**CASE NO. FP-2025-0013
ORDER OF CONDITIONAL
APPROVAL OF FINAL PLAT**

DATE: 3/17/2026
TO: City Council
FROM: Sonya Allen, Associate Planner
208-884-5533
sallen@meridiancity.org
SUBJECT: FP-2025-0013
Burnside Ridge Estates No. 1

Final plat consisting of 52 buildable lots and 15 common/other lots on 26.26 acres of land in the R-4 and R-8 zoning districts for the first phase of Burnside Ridge Subdivision.

C. Landscape Plan (dated: 1/21/26)

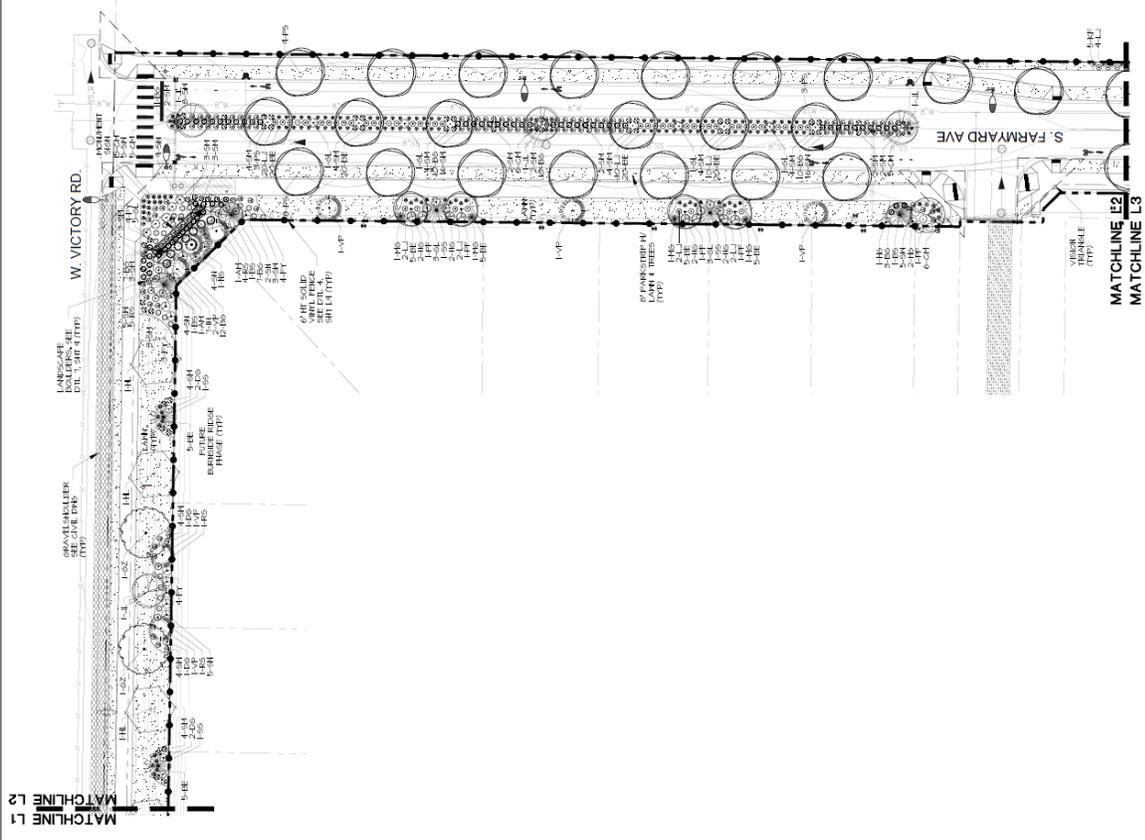
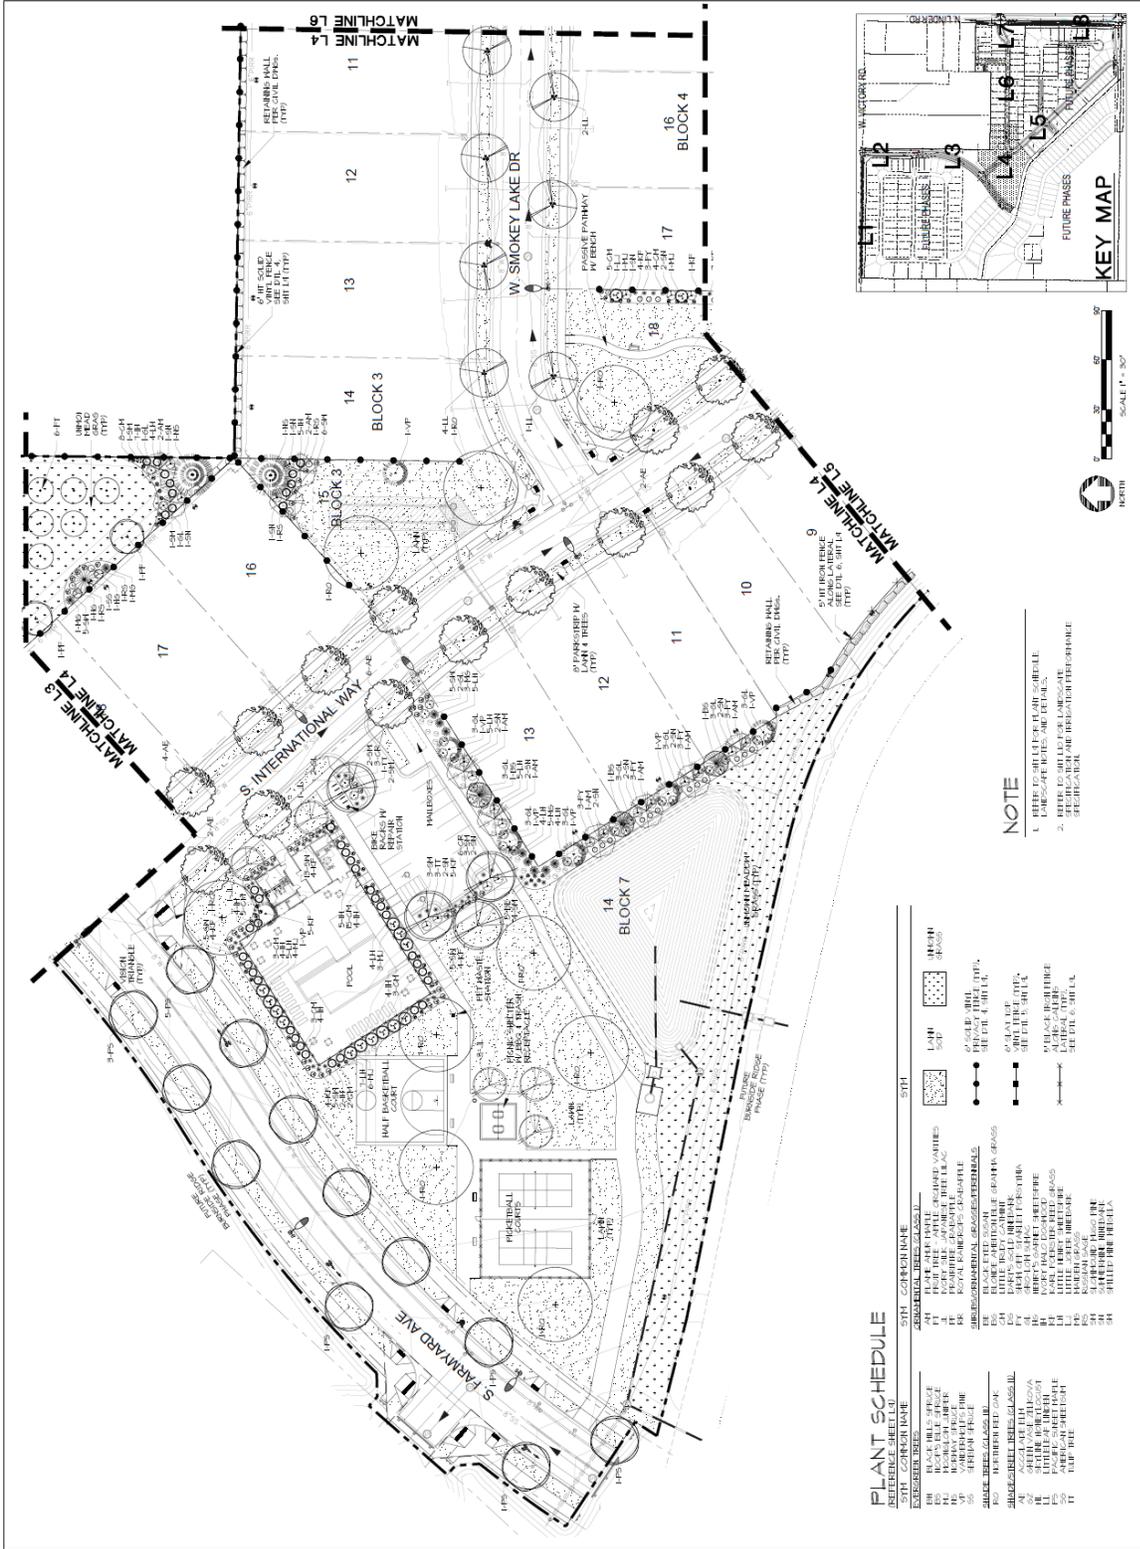
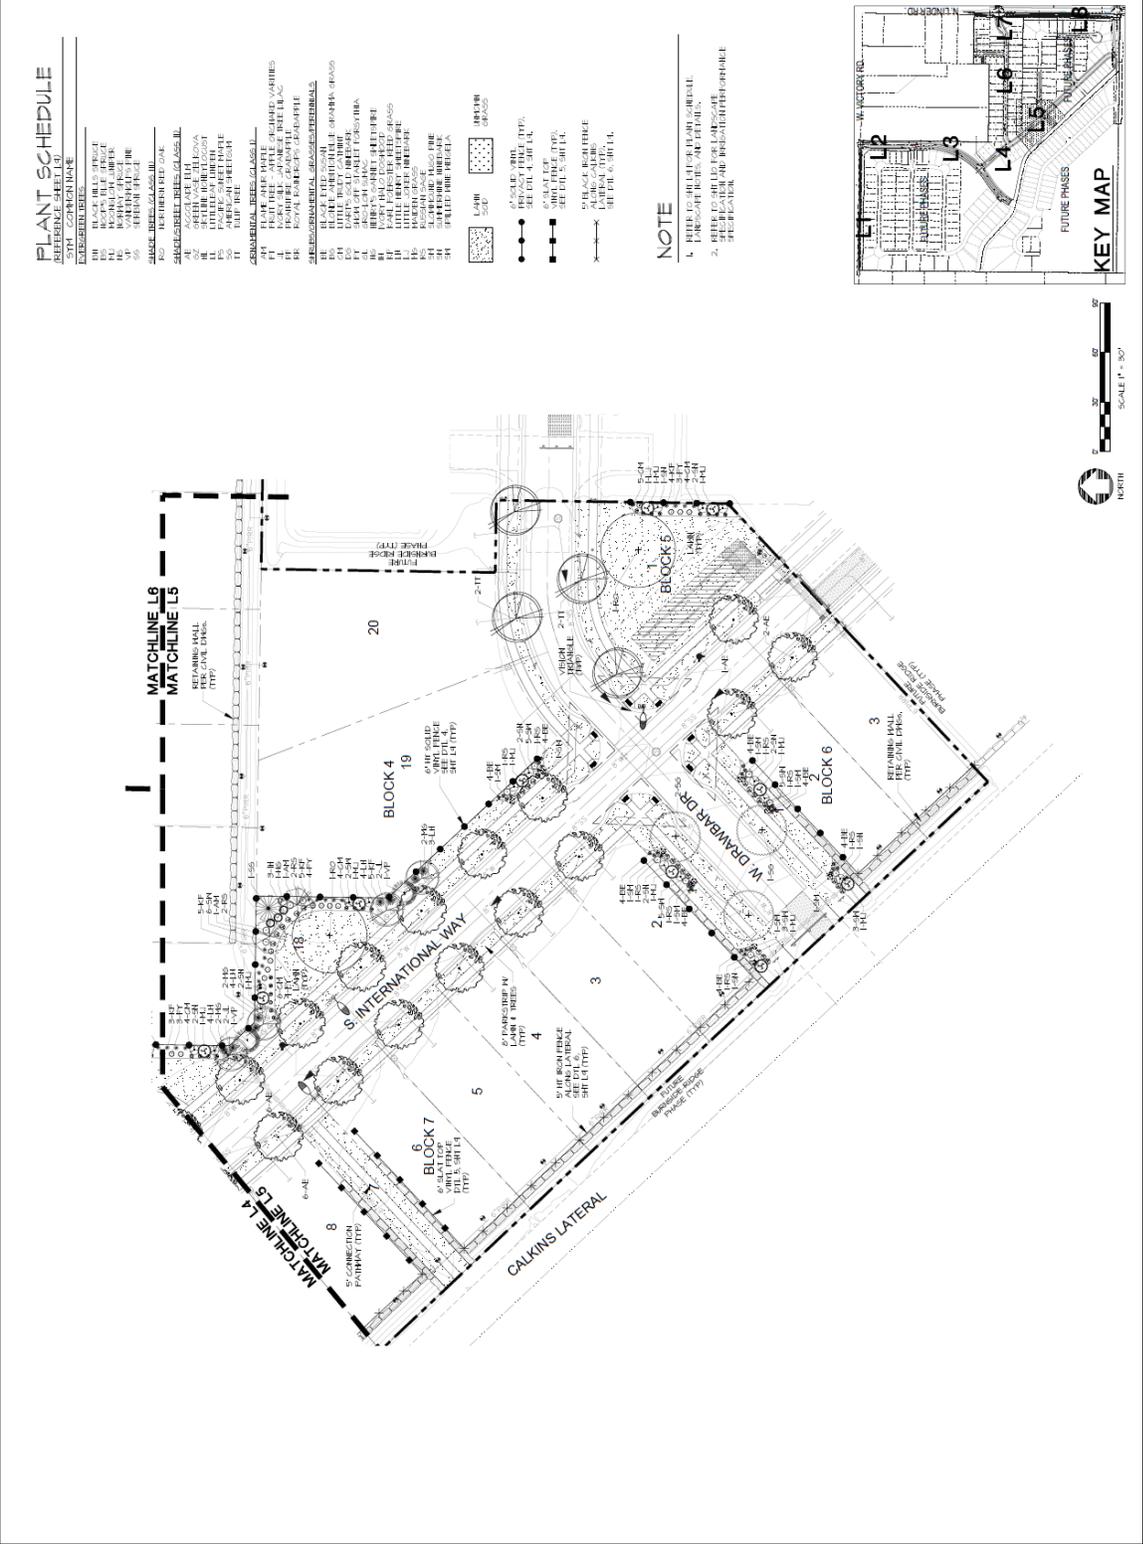
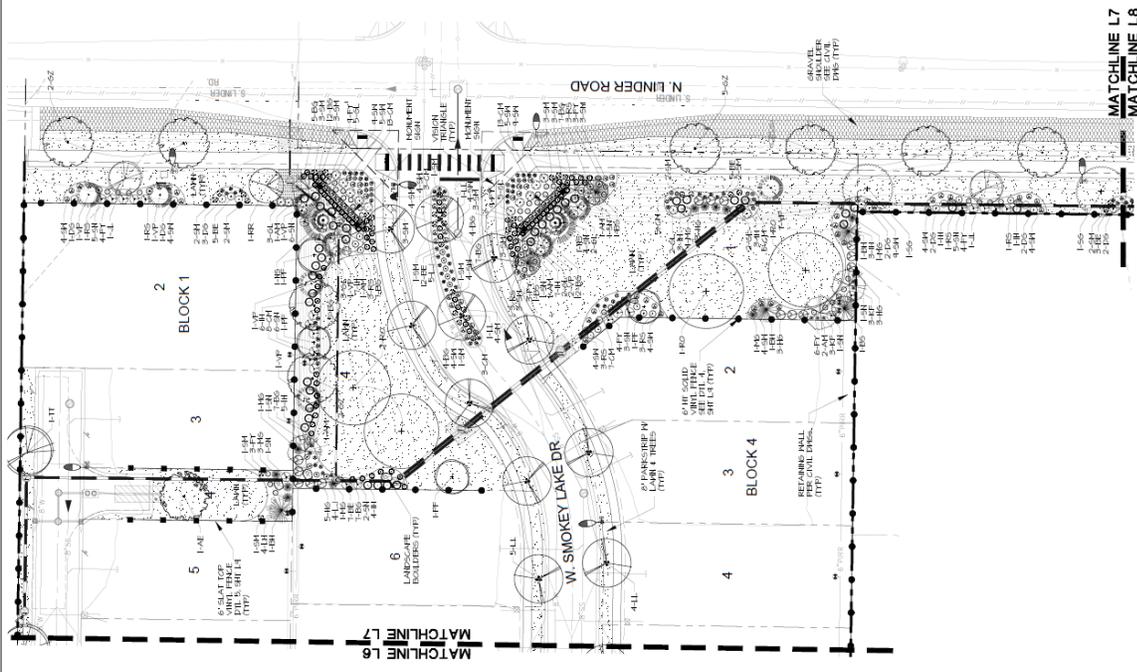
5. The landscape plan prepared by Jensen Belts Assoc., dated 8/7/25 included in Exhibit C, shall be revised as follows:
 - a. Depict a 10-foot-wide detached sidewalk along the east side of the northern portion of S. Farmyard Way, a collector street, in accord with preliminary plat condition #2g, unless otherwise approved through a development agreement modification. *If a modification to the DA isn't approved to reduce the width of the sidewalk to 5 feet, alternative compliance may be requested to provide an attached 10-foot-wide sidewalk.*

- b. Where the unimproved street right-of-way is ten (10) feet or greater from the edge of pavement to edge of sidewalk or property line along Linder Rd., a ten-foot compacted shoulder shall be depicted meeting the construction standards of the transportation authority with landscaping (i.e. lawn or other vegetative ground cover) in the remaining area, per UDC 11-3B-7C.5. *Landscaping improvements within the right-of-way shall require a license agreement between the property owner and the transportation authority.*

- c. Depict the future curb location as anticipated by ACHD along W. Victory Rd. and S. Linder Rd.; depict a minimum 25-foot-wide street buffer, measured from the ultimate curb location, along both streets.

- d. Depict landscaping with a *variety* of materials, including shrubs and vegetative groundcover, within the required street buffer along S. Farmyard Ave., a collector street, in accord with the standards listed in UDC 11-3B-7C.3; include calculations that demonstrate compliance in the Landscape Calculations table on Sheet L9.

- e. The street buffers along S. Linder Rd., W. Victory Rd., and S. Farmyard Ave. shall include enhanced landscaping as set forth in 11-3B-7C.3f with enhanced amenities with social interaction characteristics and enhanced context with the surroundings in accord with the standards listed in UDC 11-3G-3B.3. Include call-outs for what specific enhanced landscaping and amenities are proposed to meet these standards.

- f. Depict landscaping with a mix of materials along each side of all pathways, in accord with the standards listed in UDC 11-3B-12C; include calculations that demonstrate compliance in the Landscape Calculations table.

- g. Extend S. Siphon Ave. as a stub street to the north property boundary for future extension along with the sidewalks on either side (there appears to be a gap).

- h. The picnic area shall include tables, benches, landscaping, and a structure for shade in accord with UDC 11-3G-4C.5; depict accordingly.
 - i. Depict a standard bus stop (size small) with a 10' x 10' concrete pad along N. Linder Rd. just south of W. Smokey Lake Dr. (depicted as E. Pivot Dr. on the preliminary plat) as requested by Valley Regional Transit (VRT). The purpose of the pad is to provide an ADA compliance boarding/alighting area. The pad will allow VRT to schedule a stop there as part of future route planning and place signage and a bench onsite.
